Site Plan Approval Appeal Hearing

To:	Town of Kentville Council
From:	Ben Croll (Development Officer)
Date:	May 12, 2025
Re:	Site Plan Approval Appeal Hearing – Hibou Court Phase 3
Subject Property:	Hibou Court, Kentville (PID 55266314)
Lands of:	Hibous Knoll Community Living Inc.
Zone:	Medium Density Residential (R3)
Approved Plan:	A1 dated April 2, 2025, drawn by E.K.D Match Design (Appendix A)

To:	Ben Croll Development Officer	From:	Ahmad Kadri, P.Eng. Project Engineer
CC:	Darren Shupe, Director of Planning & Development Kirsten Duncan, Development Officer & Planning Technician Dave Bell, P.Eng. Director of Engineering & Public Works		
Subject:	Site Plan Approval – Hibou Court Ph3, Lands of Hibous Knoll Community Living Inc. Kentville, (55266134)	Date:	April 2, 2025

MULTI UNIT RESIDENTIAL DEVELOPMENT

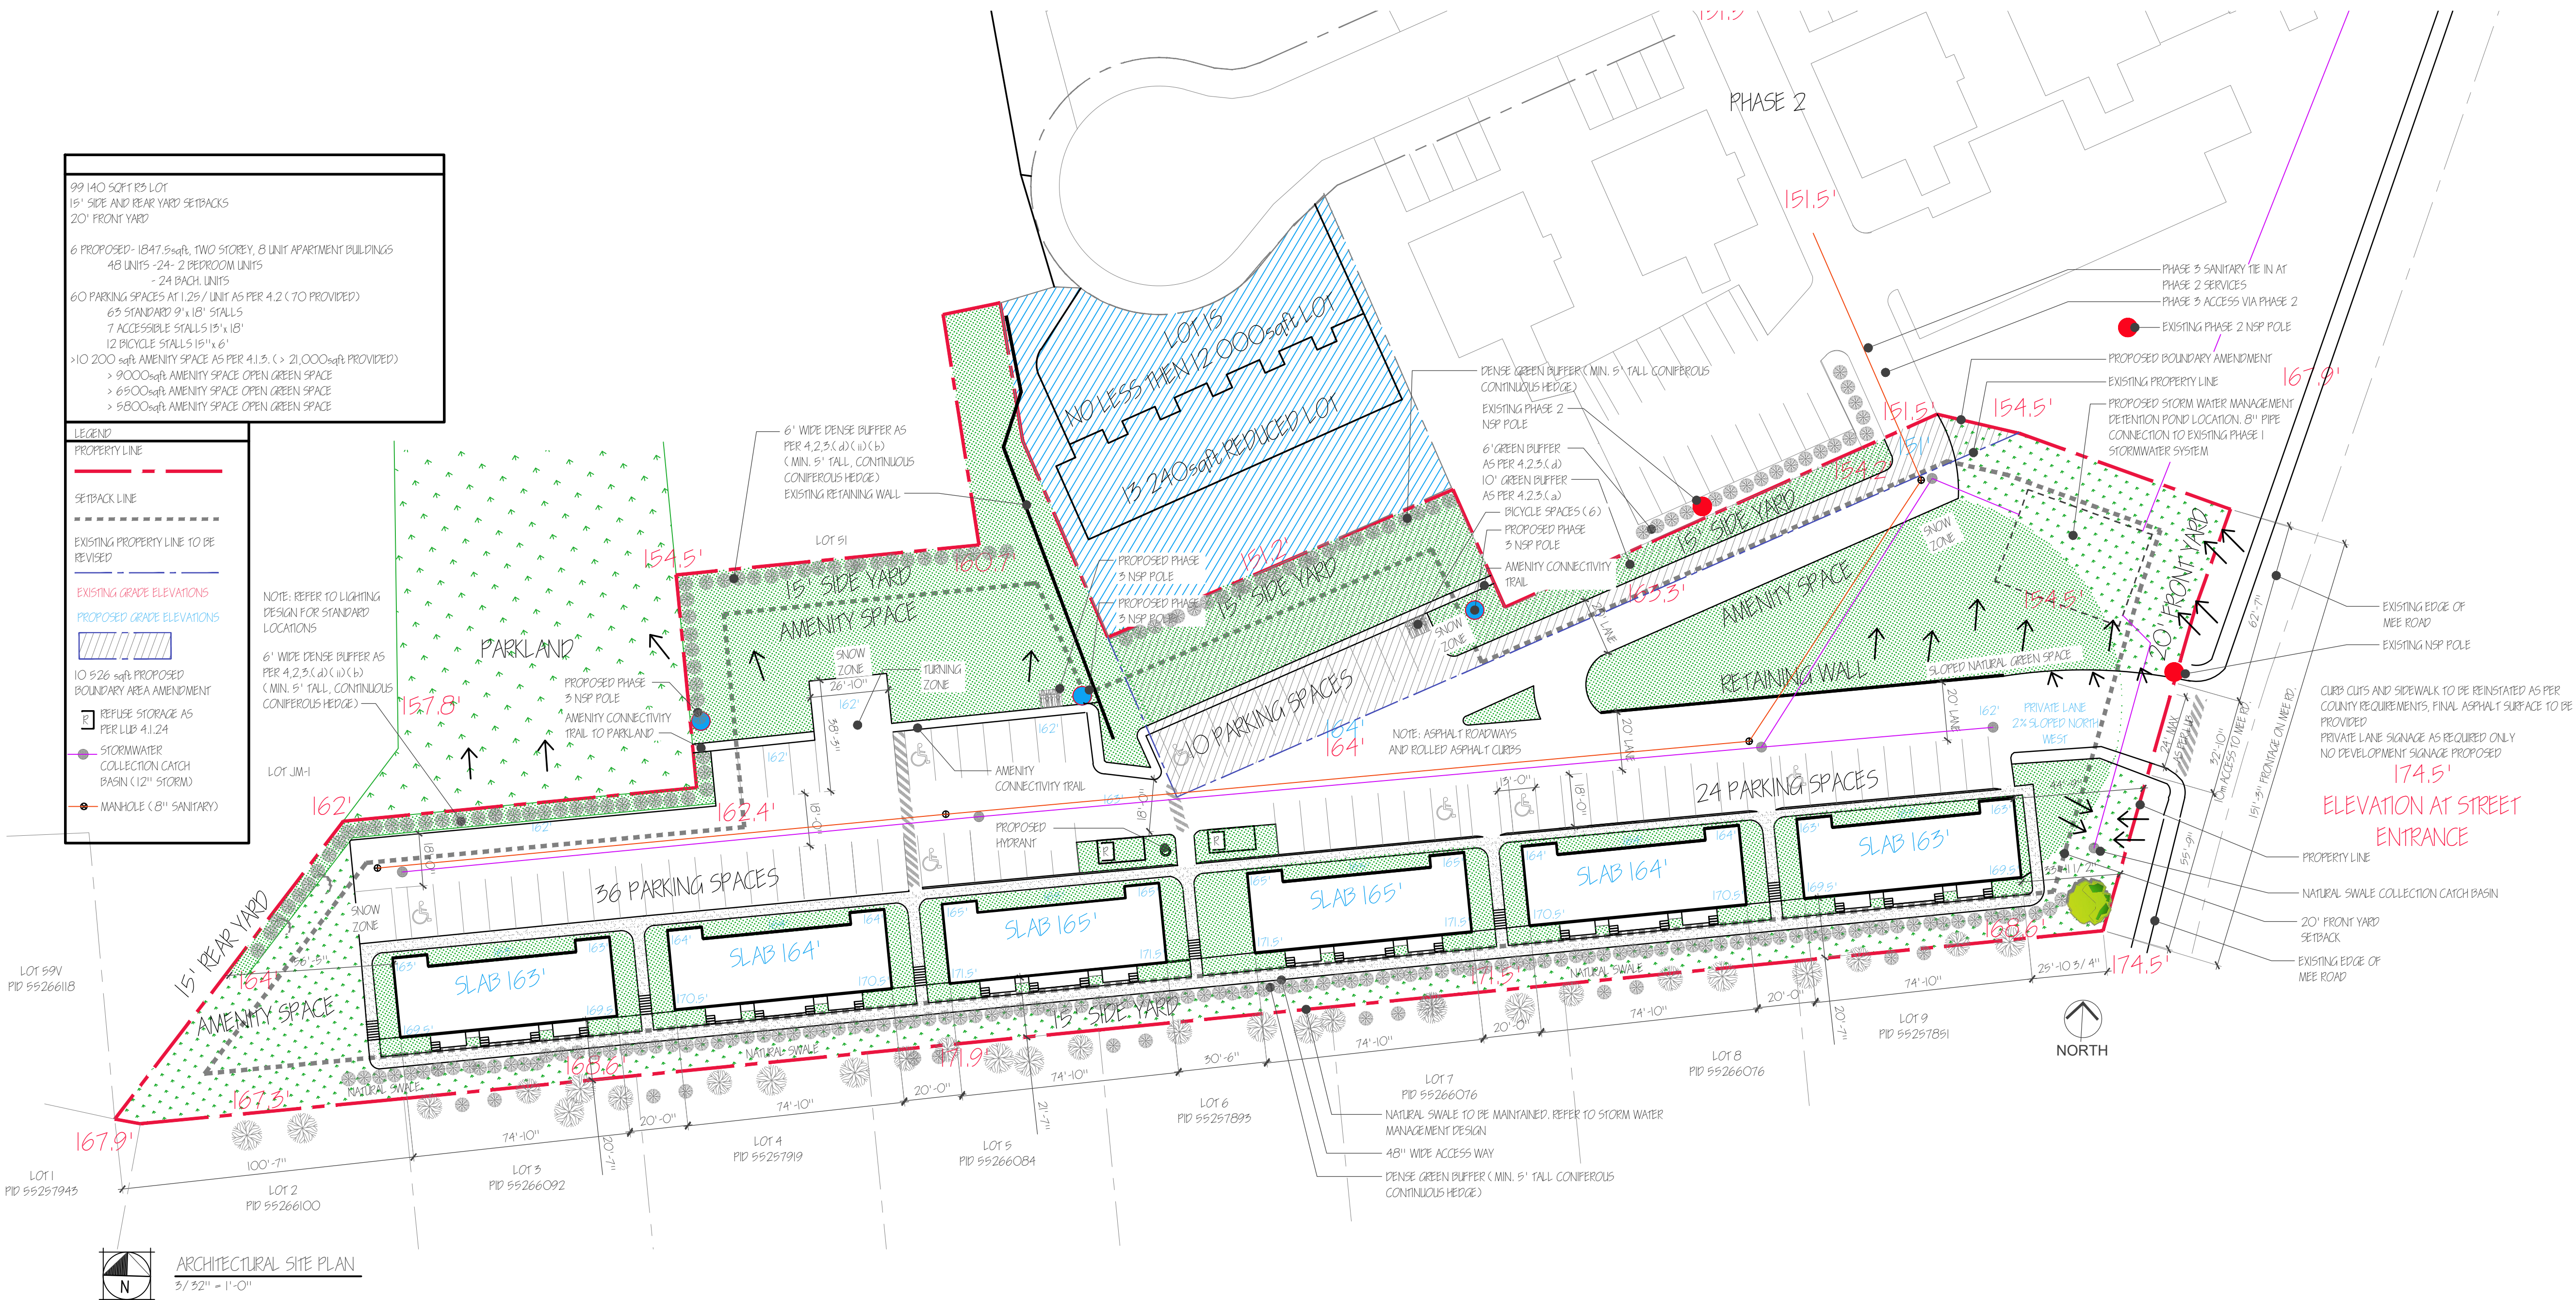
I literally live on Mountainview + this development would
5.1.12 a) The location of the new structures are located make
the minimum distance from the abutting properties which max- the
imizes the adverse impacts on the surrounding street
neighborhood rather than minimizing. b) OFFstreet parking + name
loading facilities should be underground to minimize the high-
adverse impacts + allow for more amenity space. Putting so able!
many units (the max #) is so inappropriate + adverse to

LUB REQUIREMENT	DEVELOPMENT OFFICER COMMENT
<i>a) the location of new structures (or an addition to an existing structure) is situated on the lot to minimize any adverse impacts on the surrounding neighbourhood, including, but not limited to noise, dust, or lighting;</i>	Due to the irregular shape of the lot and the proposed density, the land is being utilized efficiently. Despite the buildings directly facing the neighbours, the minimum setbacks are met, and dense buffering will be required. The Site Plan mentions a dense green buffer that is to be a minimum of 5' tall. The buffering will also be addressed to ensure it is maintained in the Letter of Undertaking. Furthermore, by satisfying all other criteria and requirements set out in the LUB, the structures are positioned to minimize adverse impacts on surrounding neighbours.
<i>b) the location of off-street parking and loading facilities is designed to minimize any adverse impact on the surrounding neighbourhood;</i>	Reviewed and approved by Engineering. (Appendix E)

<i>c) the location, number, and width of ingress and egress points are designed to prevent traffic congestion, nuisance, and inconvenience in the area and minimize any adverse impact on the surrounding neighbourhood;</i>	Reviewed and approved by Engineering. (Appendix E)
<i>d) the type, location, and height of walls, hedges, fences, trees, shrubs, ground cover, or other landscaping elements are designed and constructed to</i>	A dense green buffer is indicated along the southern property line. The height is now addressed as it is labelled to be a minimum of 5' tall. This will also be addressed in the

<i>protect and minimize any adverse impact on neighbouring properties;</i>	Letter of Undertaking to ensure it is maintained. The revised Site Plan added buffering between the amenity space area and lot 51 (35 Hillcrest Ave).
<i>e) the existing vegetation, where possible and deemed practical, shall be retained to lessen or reduce any adverse impact on abutting properties or the surrounding neighbourhood;</i>	Existing vegetation surrounding the property will be enhanced and maintained.
<i>f) the location of pedestrian walkways, and/or related infrastructure, shall be provided to link public walkways and parking areas to the entrance of the primary building;</i>	Overall, there is good connectivity within the development. Connectivity has been added to the site plan to connect to the existing phases. Connectivity to the proposed parkland is now provided.
<i>g) the type and location of outdoor lighting is designed to illuminate the structure, driveways, and any pedestrian walkways, but shall not be directed onto neighbouring properties;</i>	Lighting plan provided and appears appropriate (Appendix F).

<i>h) the location of facilities for the storage of solid waste provides for maximum separation from residential development, public areas, and adjacent properties;</i>	Site Plan addresses refuse storage and meets regulations of section 4.1.24.
<i>i) the location of existing easements shall be identified;</i>	No easements on the Subject Property. The two easements registered are from NSP and surround the cul-de-sac affecting Phase 1 and Phase 2.
<i>j) the management of storm and surface water is addressed, and associated plans are approved by the Town Engineer;</i>	Stormwater Management Plan reviewed and approved by Engineering (Appendix E).
<i>k) the type, location, number, and size of signs or sign structures do not</i>	No development sign is being proposed. Only a private lane sign.

<i>negatively alter the appearance of the neighbourhood; and</i>	
<i>l) the above-listed items are maintained in a manner suitable and complementary to the surrounding neighbourhood."</i>	All criteria are met with no further concerns.

All zone requirements are met and demonstrated on the Site Plan.

The proposed development provides 21,000 ft² of amenity space, exceeding the minimum requirement.

Based on this table, this development requires 1.25 parking spaces per unit. With 48 units, 60 parking spaces are required. The Site Plan proposes 60 parking spaces, meeting the requirement. However, as there are four or more parking spaces, Section 4.2.3 of the LUB also applies. Below are the regulations with the comments from the Development Officer:

The Site Plan provides several dedicated areas that are not in the front yard and therefore do not require a wholly enclosed structure. The dedicated areas also not occupy any parking or amenity space.

For this proposed development, the minimum distance is 20 feet, which is demonstrated on the Site Plan.
